CHAPTER - 34 HIGHLIGHTS (Summary of Changes)

Revision No. TR34-11 Sep 30/20

TO: HOLDERS OF THE AIRCRAFT MAINTENANCE MANUAL (06-123838)

Pitot/AOA Probes - Removal/Installation
Figure 401 (Sheet 1 of 5)

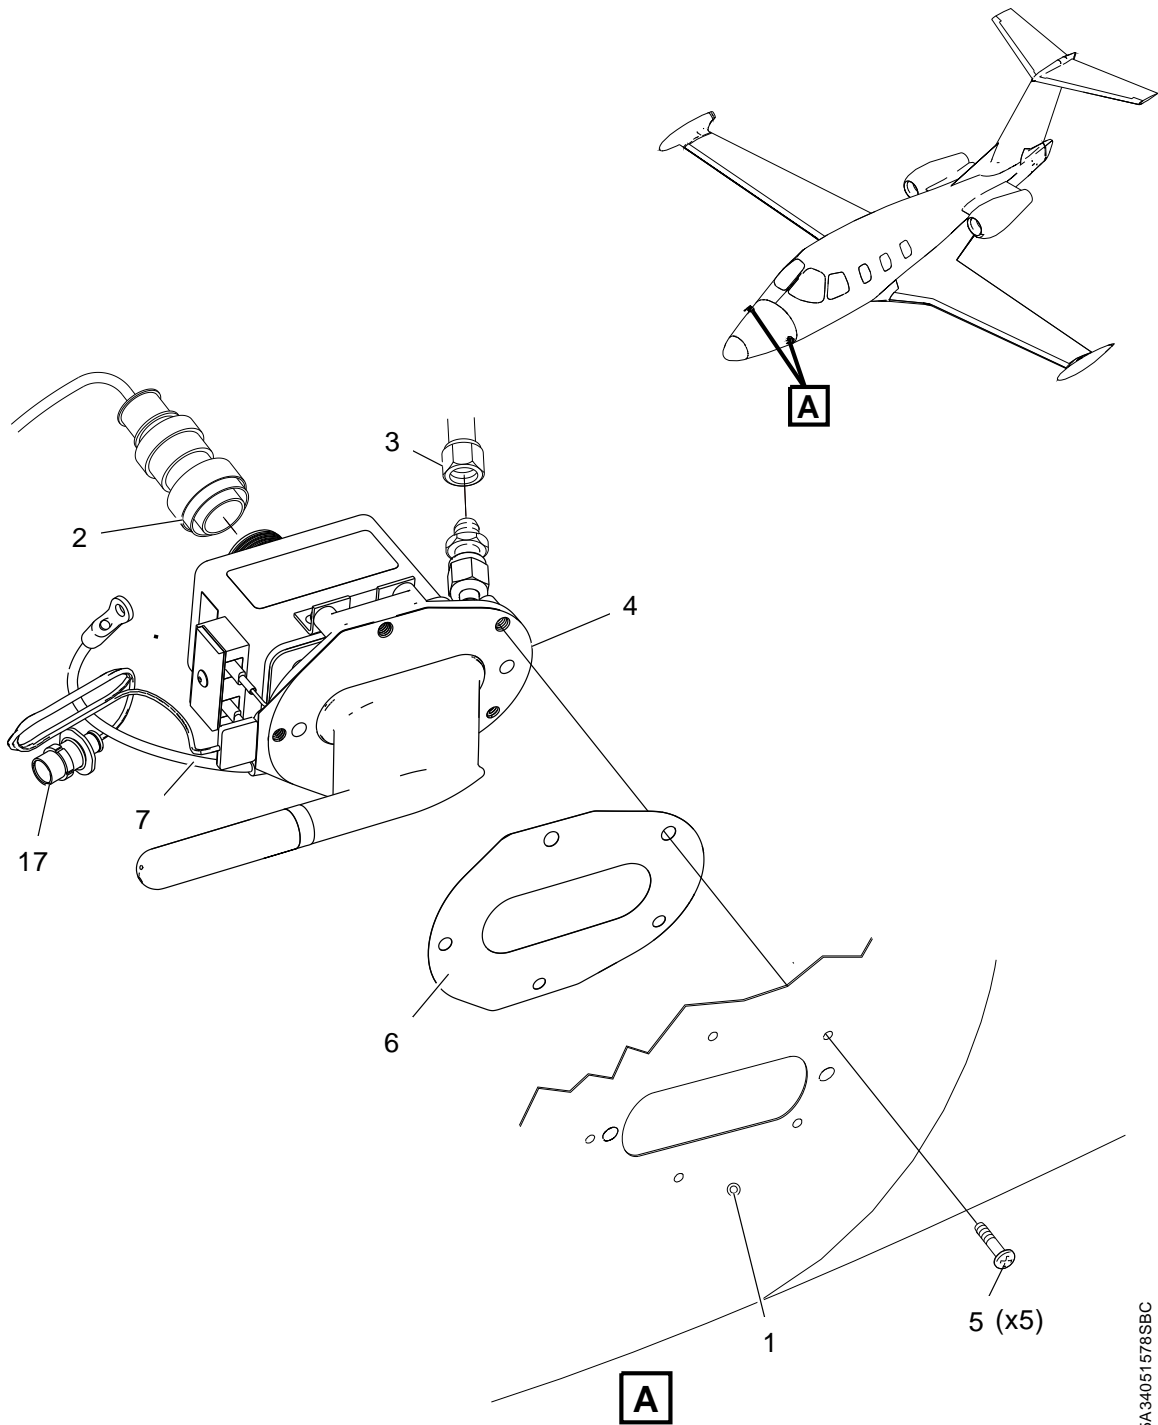
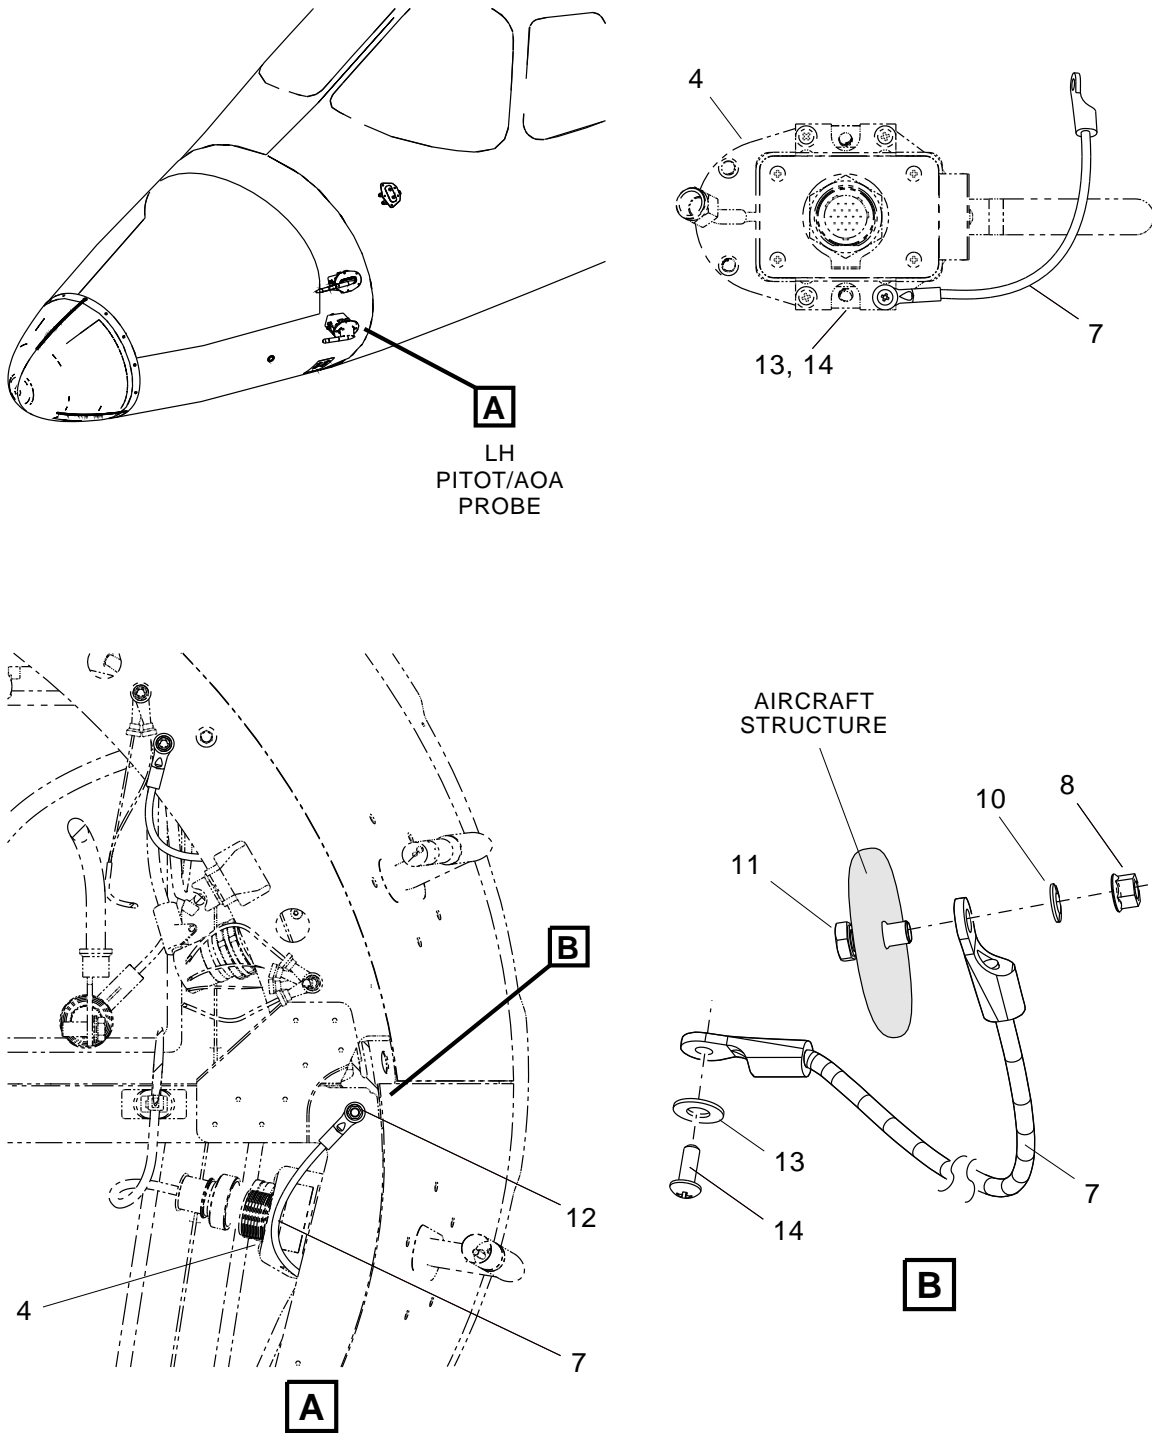
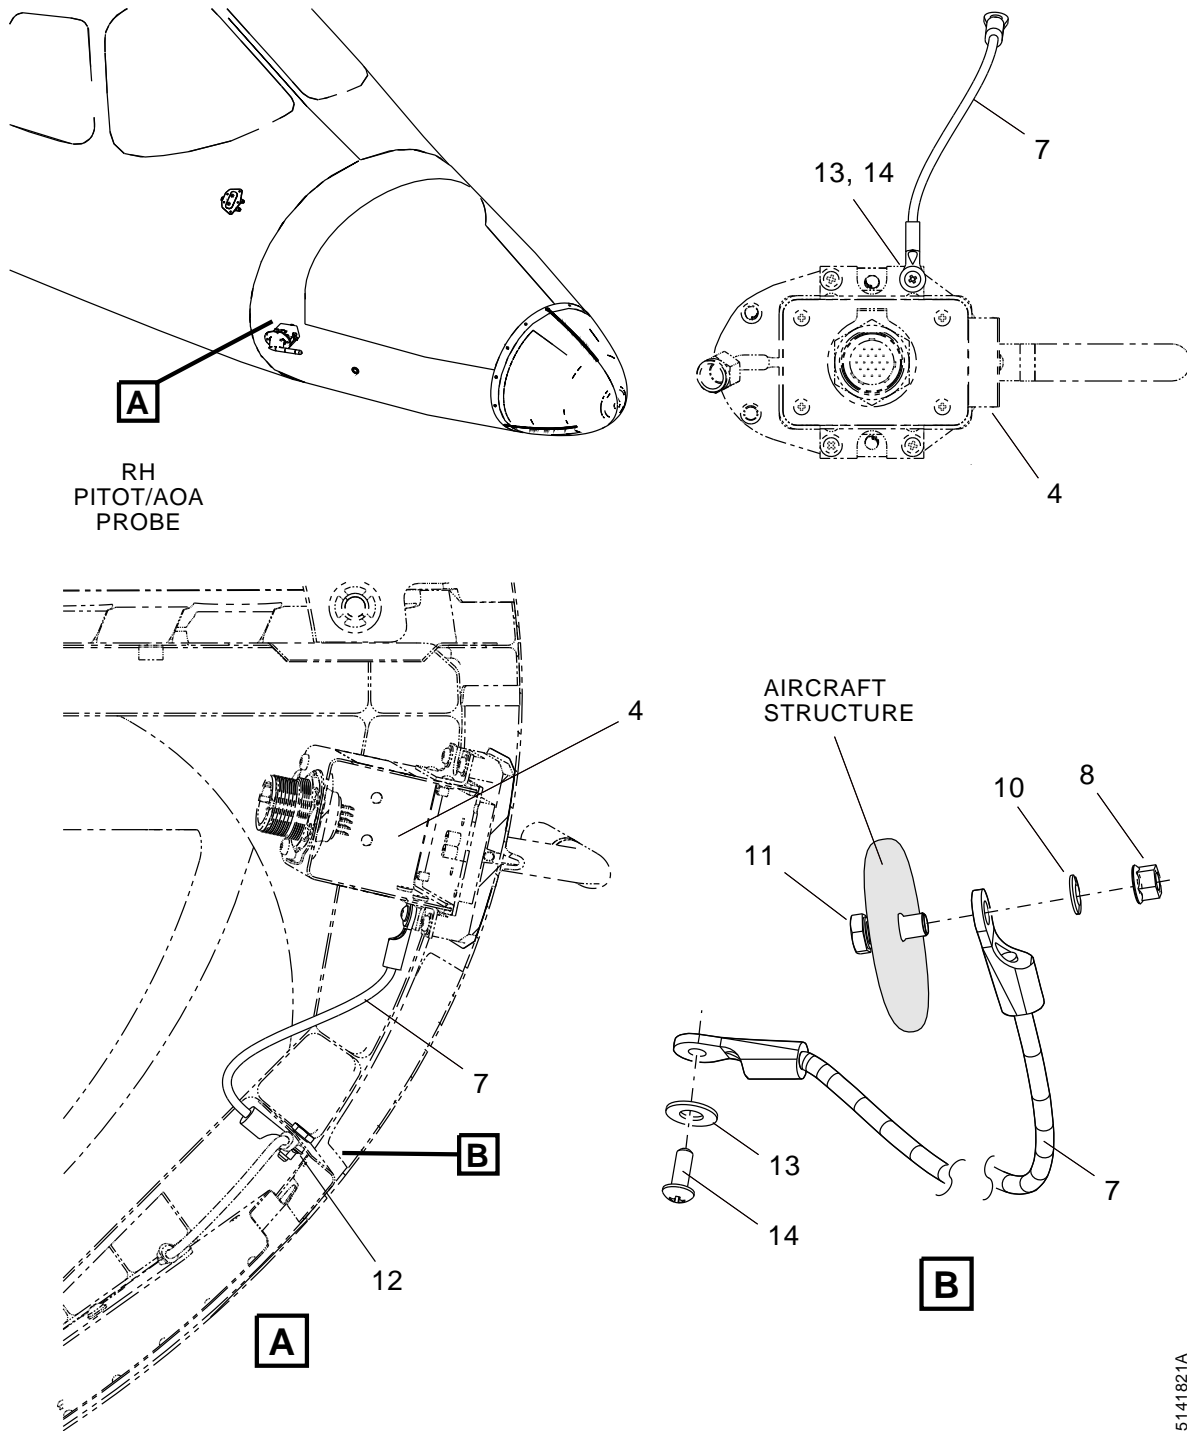
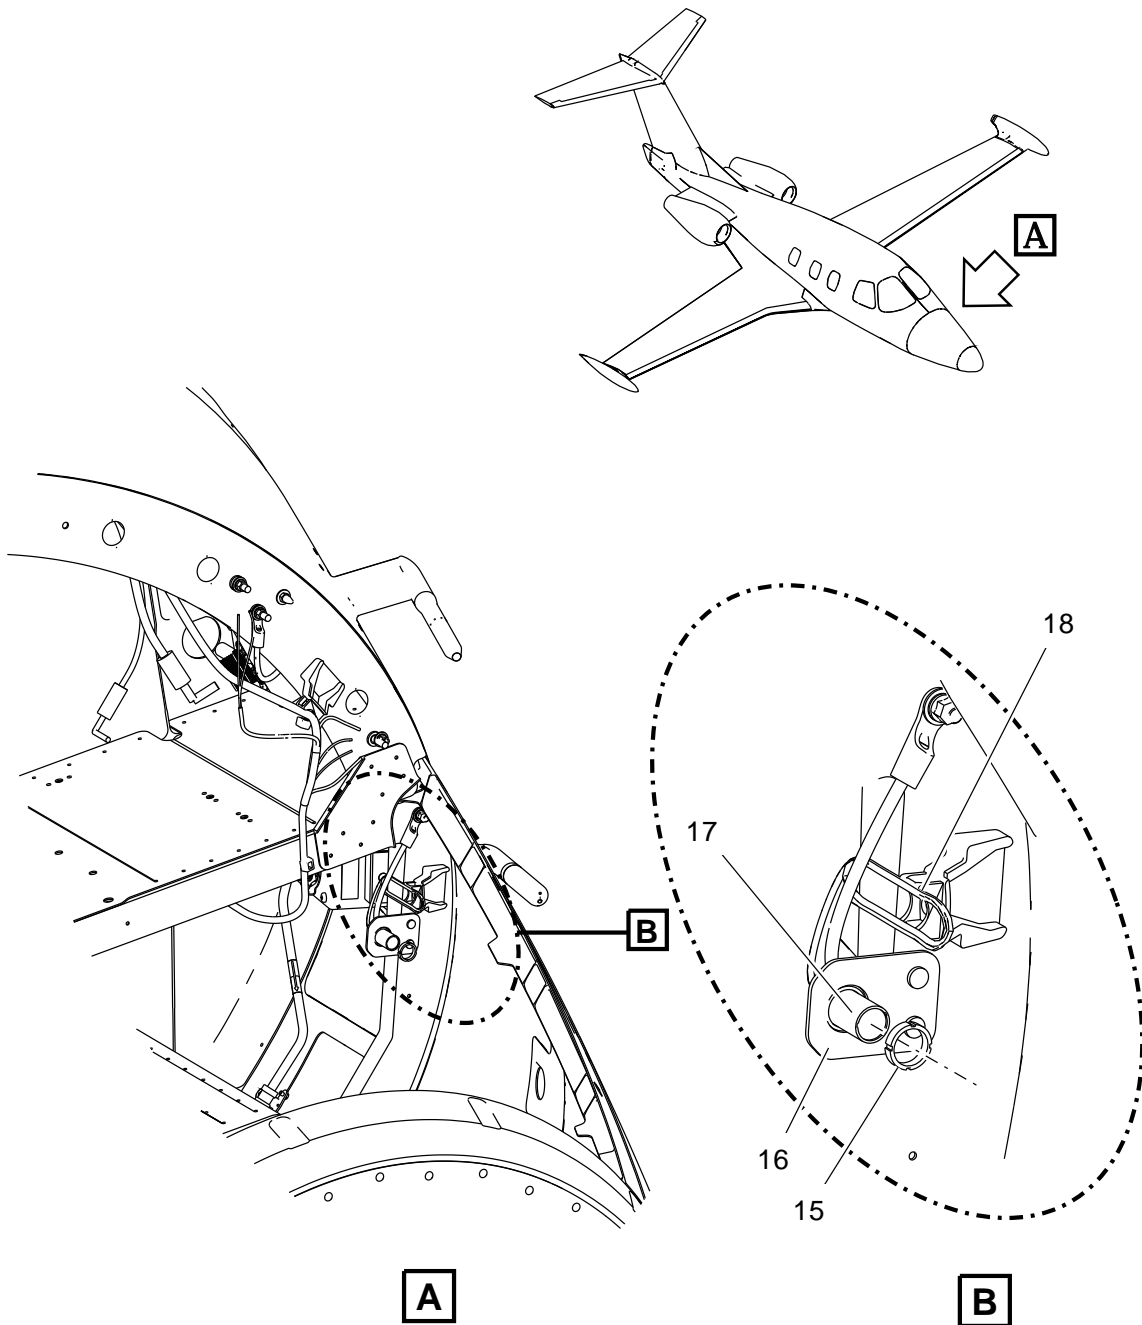
| CH/SE/SU Page Block No. | Description of Change |
|-----------------------------------|---|
| 34-10-10 PgBlk 401-Inst (C) | Added auxiliary heaters to Pitot/AOA Probe - Installation - Config C. |

GPS - Removal/Installation
Figure 401 (Sheet 1 of 1)

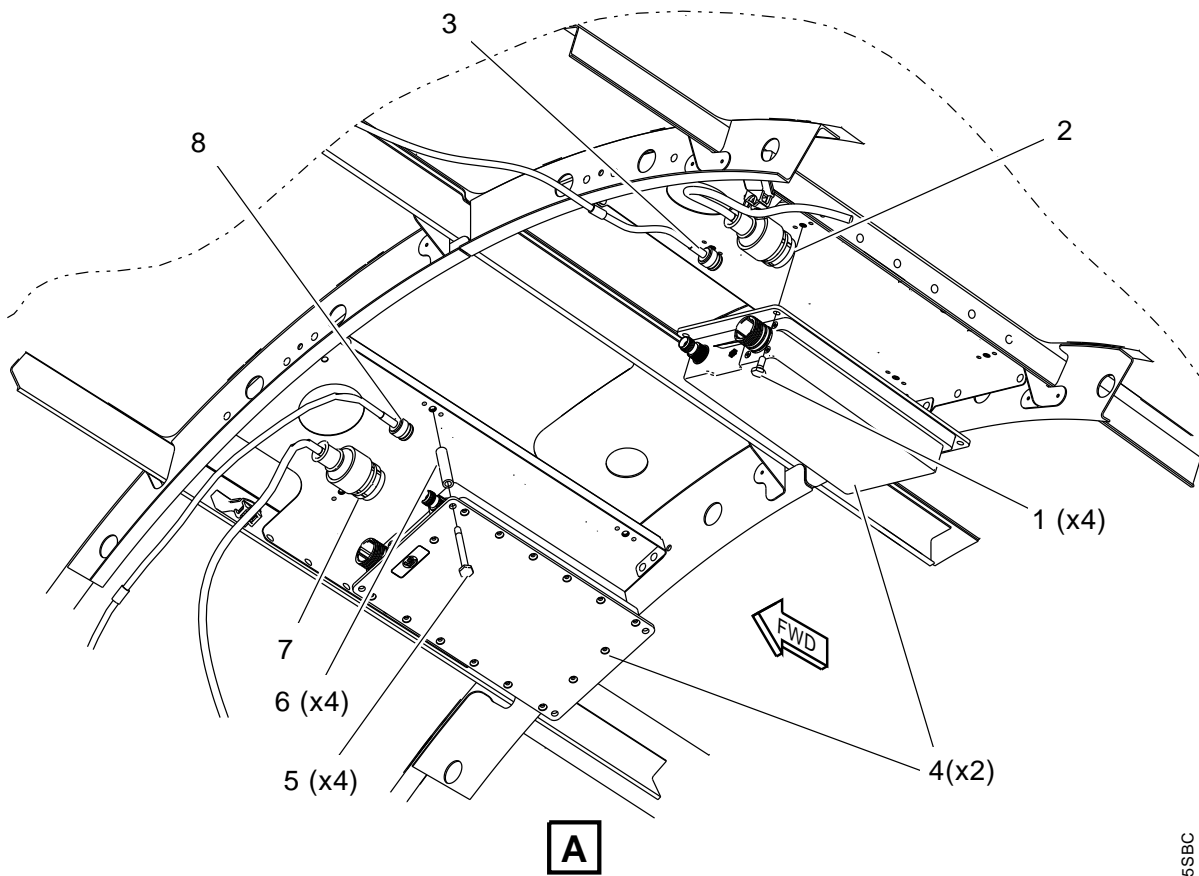
| CH/SE/SU Page Block No. | Description of Change |
|-----------------------------------|---|
| 34-50-11 PgBlk 401-Rem | Corrected Figure 1. |

GPS - Removal/Installation
Figure 401 (Sheet 1 of 1)

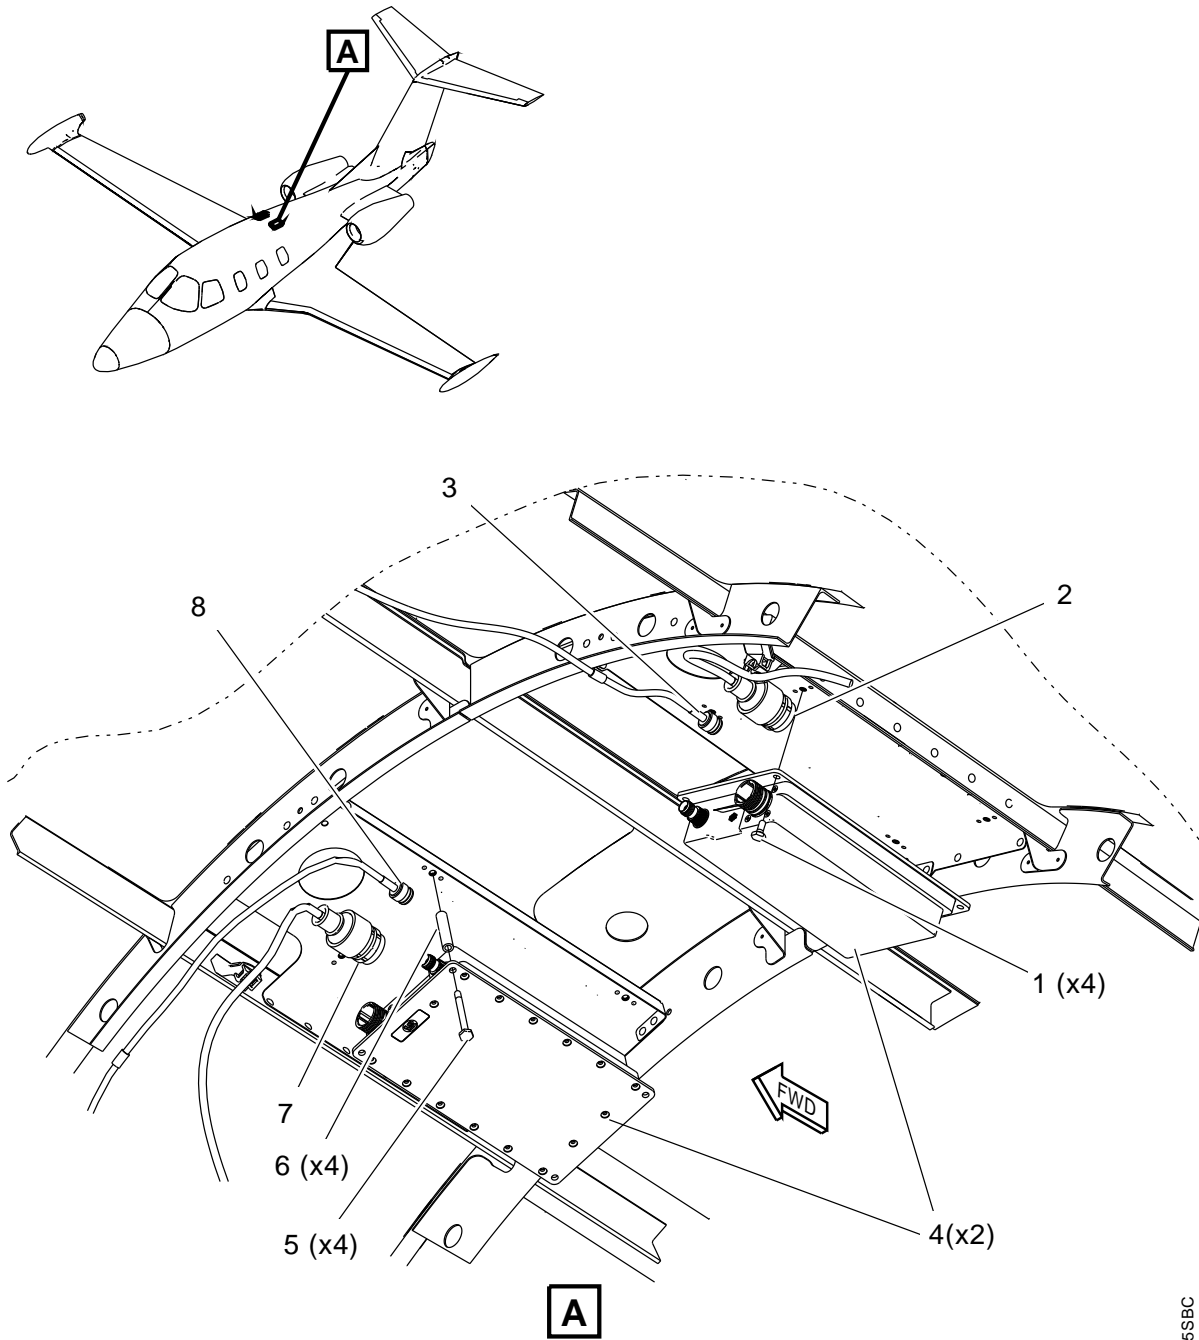
| CH/SE/SU Page Block No. | Description of Change |
|-----------------------------------|---|
| 34-50-11 PgBlk 401-Inst | Corrected Figure 1. |
